DEVELOPMENT APPLICATION FOR PROPOSED MINGARA RECREATION CLUB SENIORS HOUSING, TUMBI UMBI

RESPONSE TO THE EXHIBITION BY THE GLENGARA VILLAGE RESIDENTS' COMMITTEE (GVRC)

Development details: Application number SSD-63475709

Figure 6 – Age distribution Central Coast

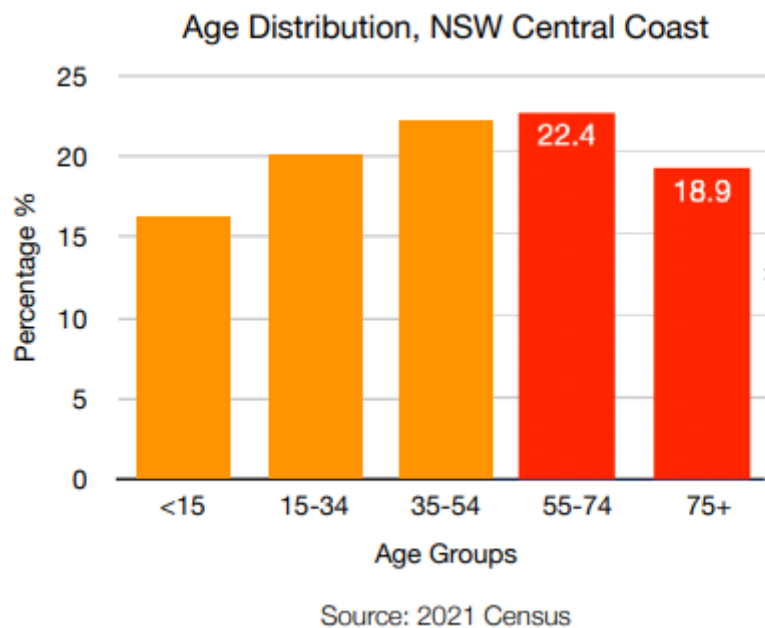
GVRC acknowledges the growing ageing population in the local council area – see Figure 6 below.

GVRC acknowledges that the proposal complies with local planning aims and does not object in principle to the proposal to develop seniors housing on this site.

Figure 9 - Extract of Shadow Diagrams on June 21st (Winter Solstice)

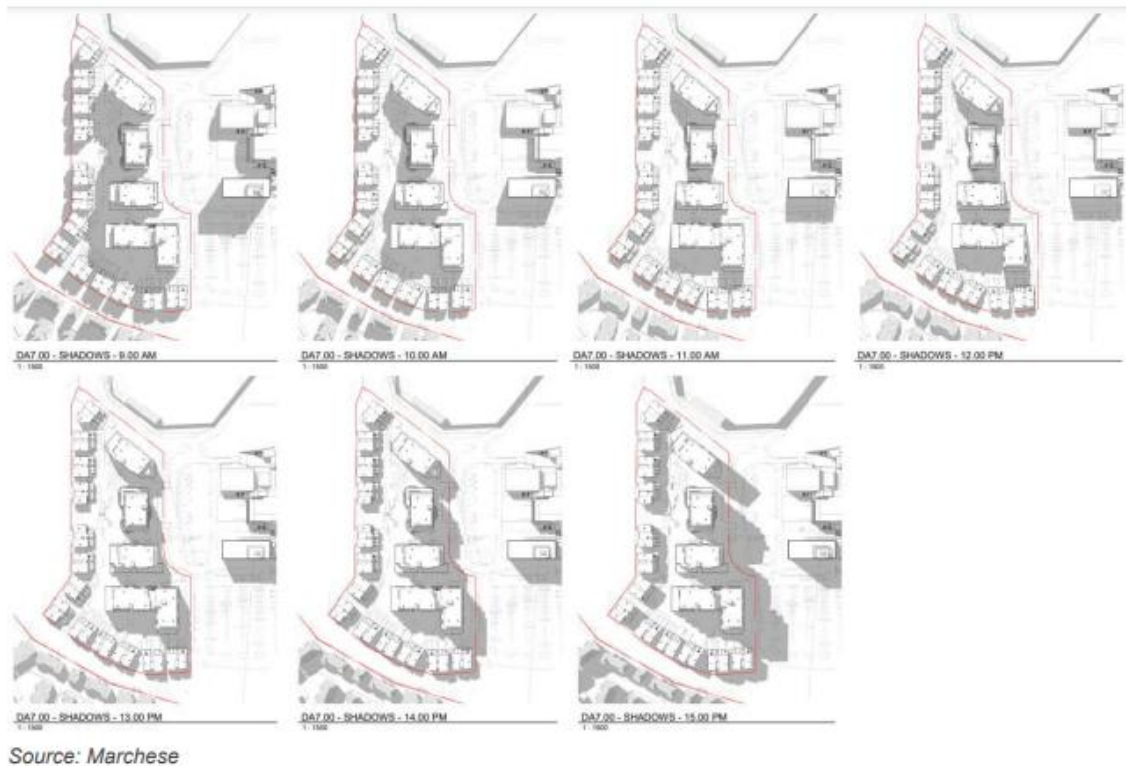
The EIS presents overshadowing diagrams (see below) that indicate that the Glengara Village residents will not be affected by significant overshadowing. It claims that the development ensures the proposed communal open spaces located within the Tumbi Umbi Retirement Village, to the north and south benefit from a high degree of solar access to ensure maximum enjoyment and useability. It states that the development

GVRC is pleased to note the proposed building setback of 20m to the southern boundary (the proposed development's closest neighbours). It does recognise that the Glengara Village residents at this boundary do already experience noise and light pollution from the existing Club, Hotel and Athletics and that they could not reasonably expect the current grassed area of the development site to remain so forever.

It does not agree with the apparently subjective statement in the EIS that the development "will not result in any significant adverse impacts to nearby residential properties, including visual, overshadowing or privacy impacts." It believes that that statement is an affront to the neighbours and it brings into question the independence of the EIS. The near presence of 258 new dwellings (with a population of the order of 350 people) must have an impact on these matters. This matter is also related to the view of GVRC that the proposed development is an over development of the site. These claims need a review by an independent expert planning consultant.

GVRC proposes that the conditions of any consent should require the developer to develop a vegetation plan for the 20m setback from the Glengara Village boundary to the south of the development, in close and meaningful consultation with those Glengara residents, to mitigate the effect of noise, light and visual impact on them resulting from the development.
